PROJECT:
SINGLE-FAMILY RESIDENCE (FIRE REBUILD)
DETACHED GARAGE
ADDRESS:
15303 EARLHAM ST, PACIFIC PALISADES, CA 90272

**STAMPER
RESIDENCE
FIRE REBUILD**

**Cover Sheet /
Project Info /
Sheet Index**

Exterior Elevations N&S

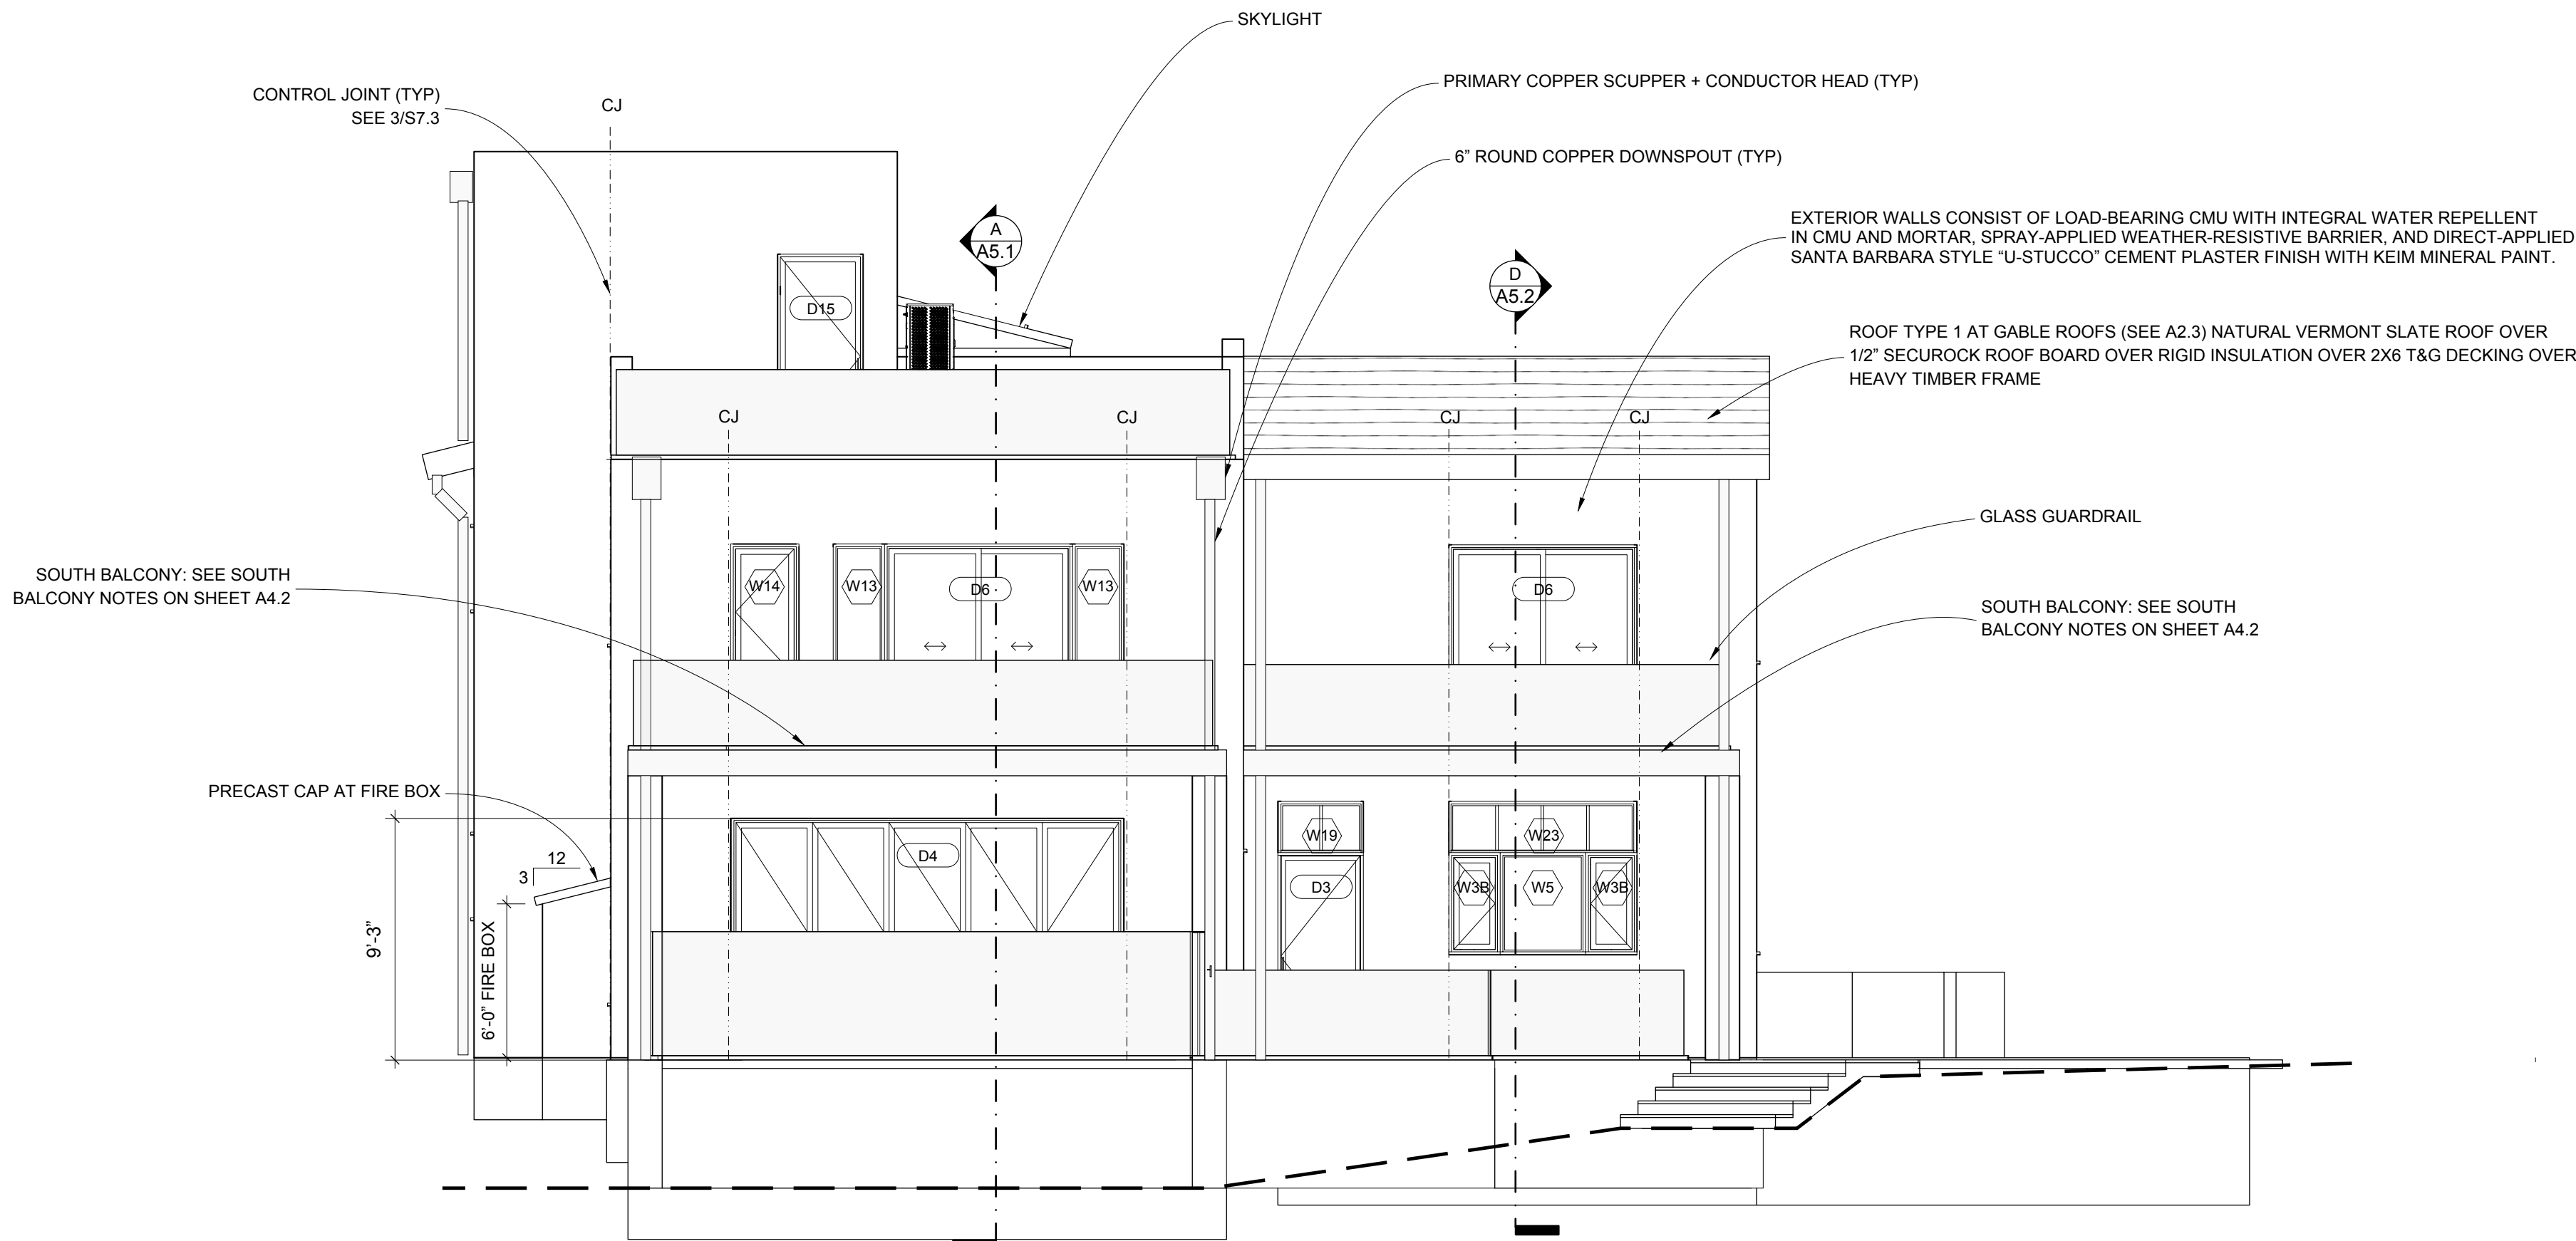
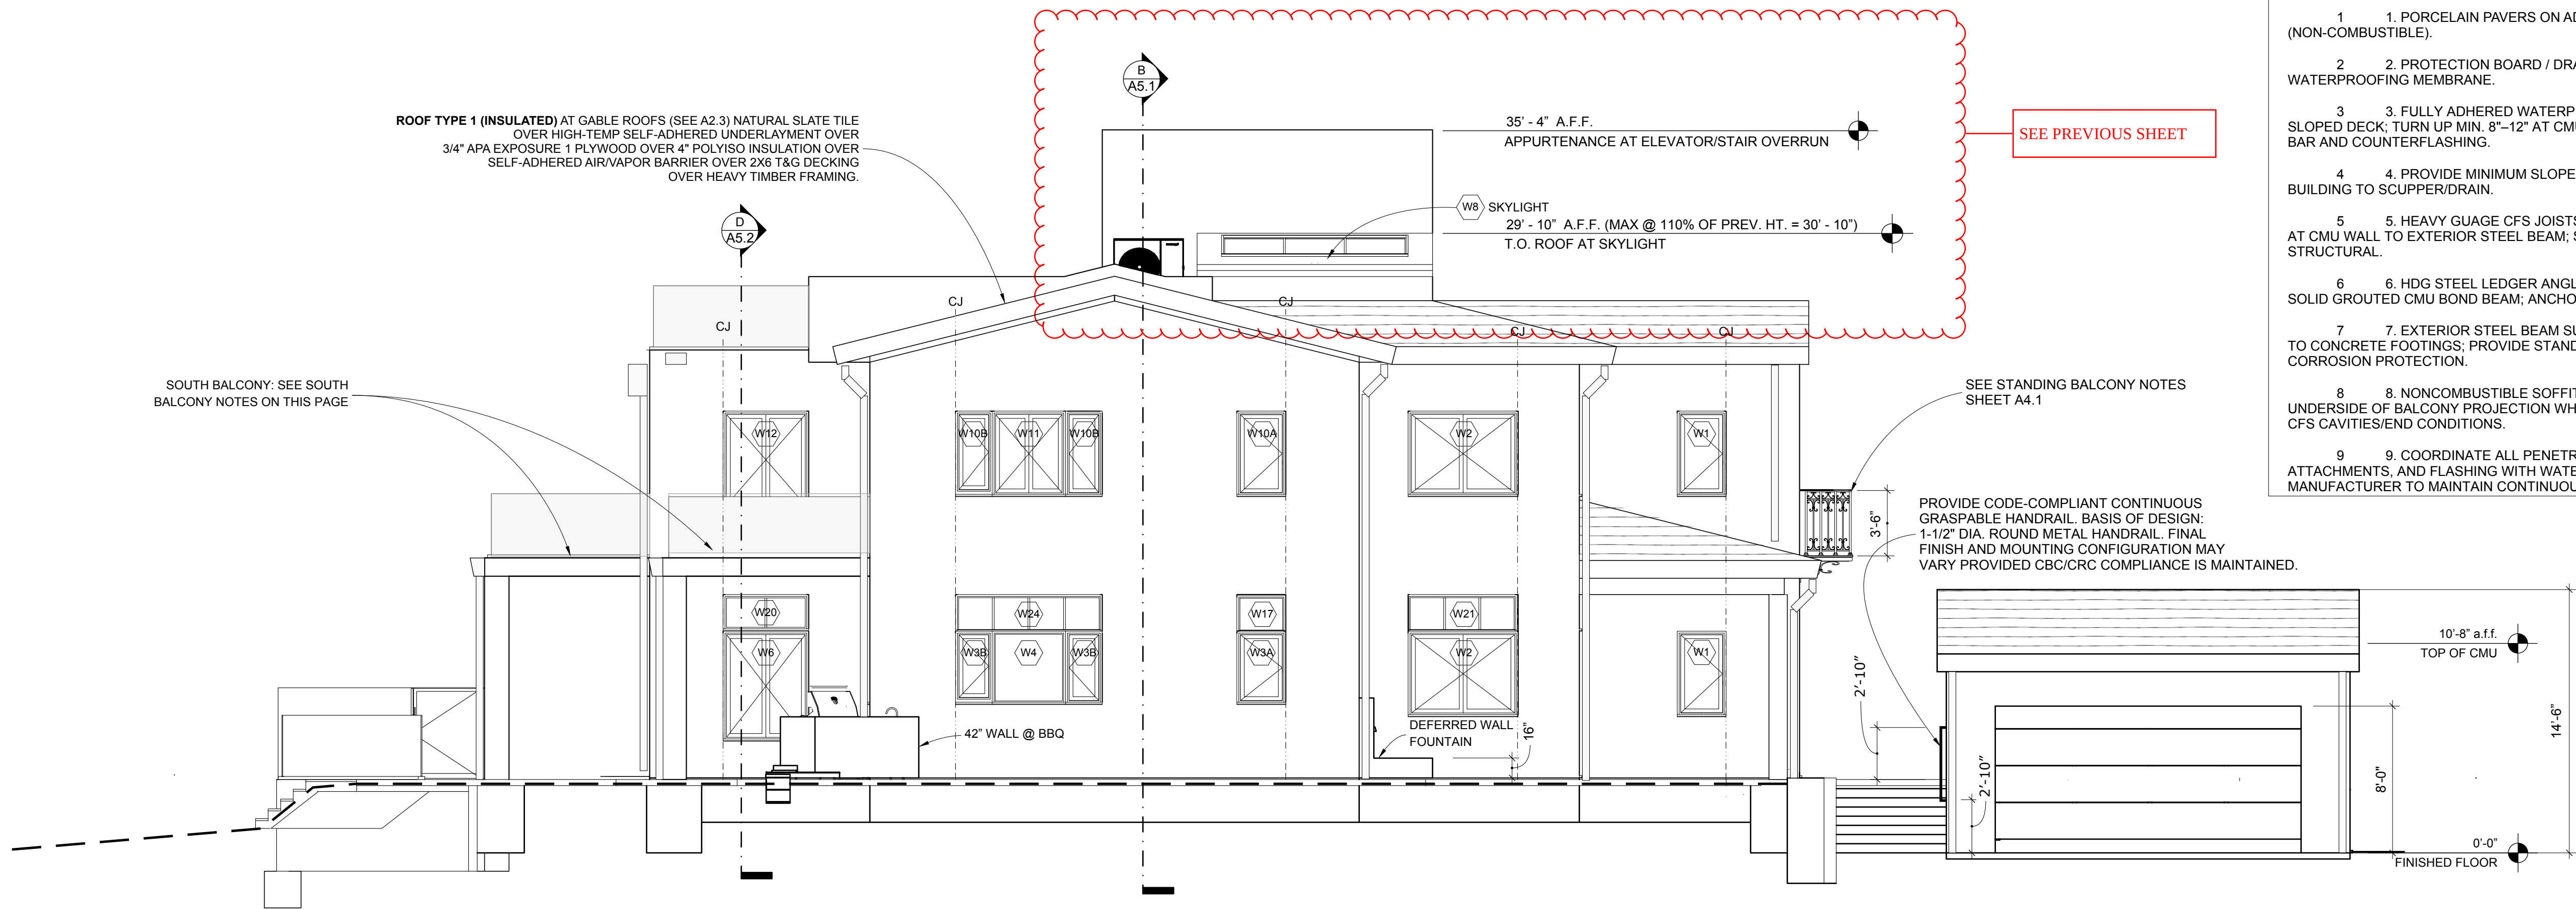
Provide Height of Building shown from the lowest point of elevation within 5 feet around the building.

Show location on site plan

Show and comply with Encroachment Plane on the Elevations originating from a point 20 ft. in height along the required front yard and side yard setbacks per LAMC 12.08 C5(a)

IF PROJECT IS SHOWN TO BE EO1 ELIGIBLE THEN ENC PLANE IS NOT REQUIRED

Exterior Elevations E&W

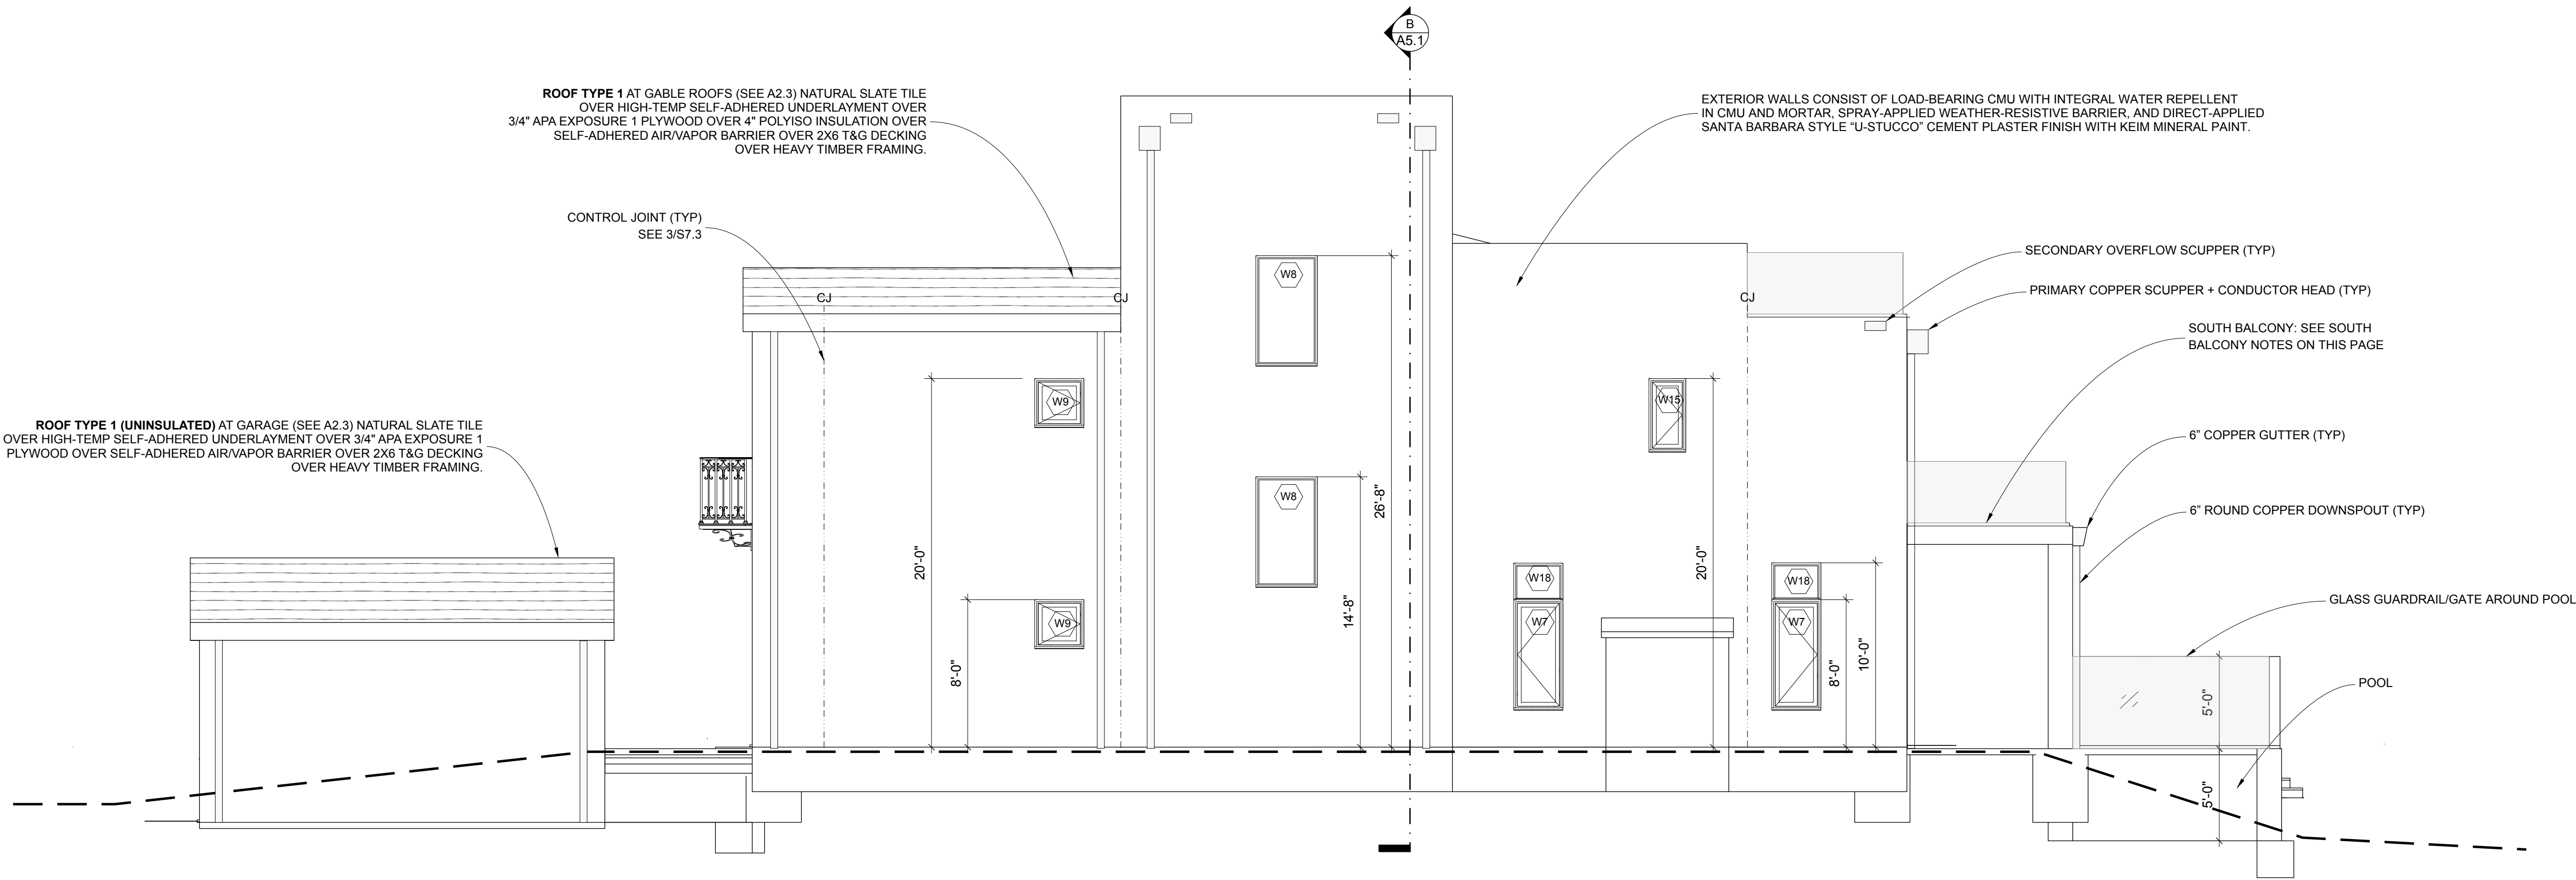
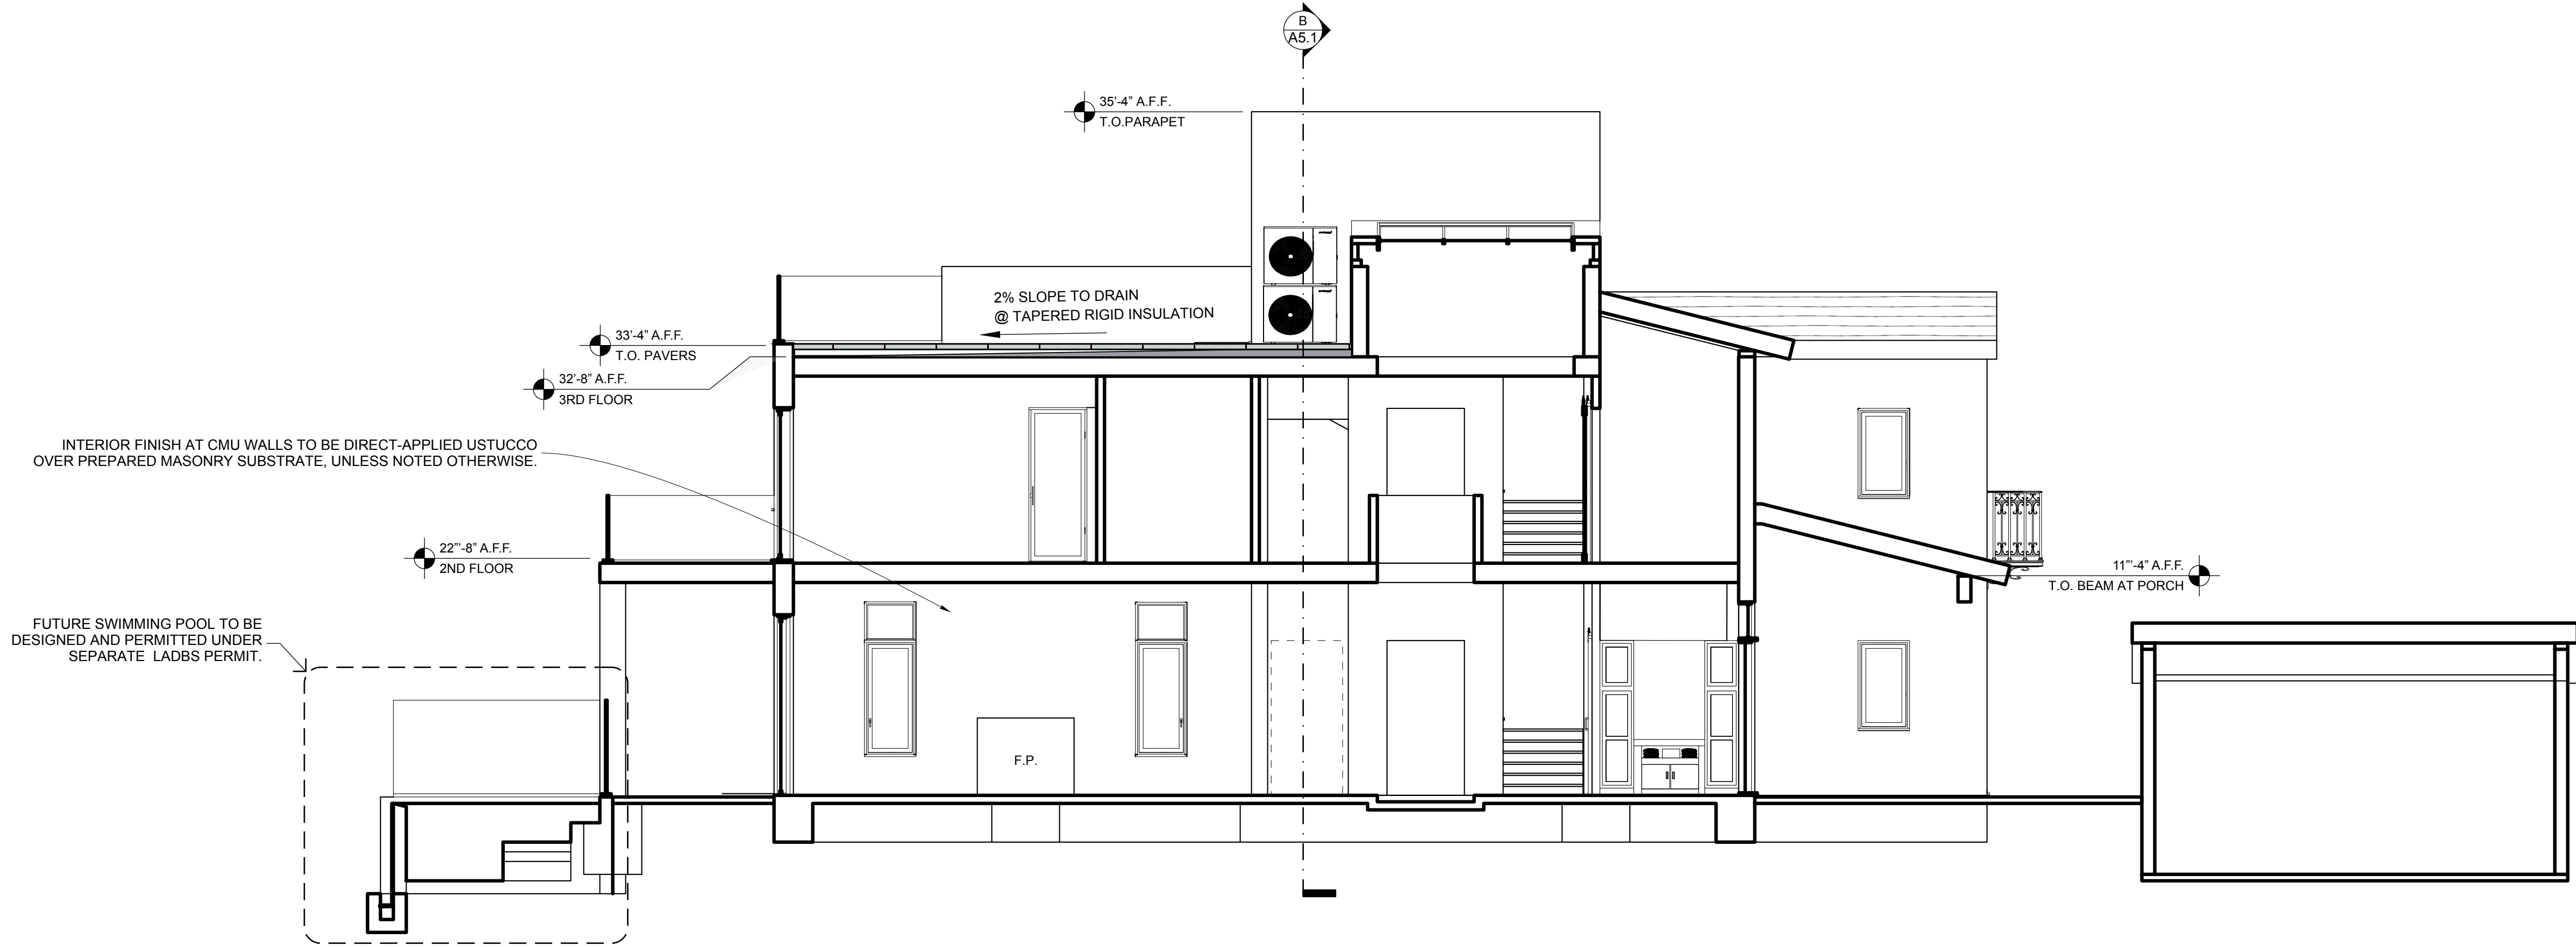
Show and comply with Encroachment Plane on the Elevations originating from a point 20 ft. in height along the required front yard and side yard setbacks per LAMC 12.08 C5(a)
IF PROJECT IS SHOWN TO BE EO1 ELIGIBLE THEN ENC PLANE IS NOT REQUIRED
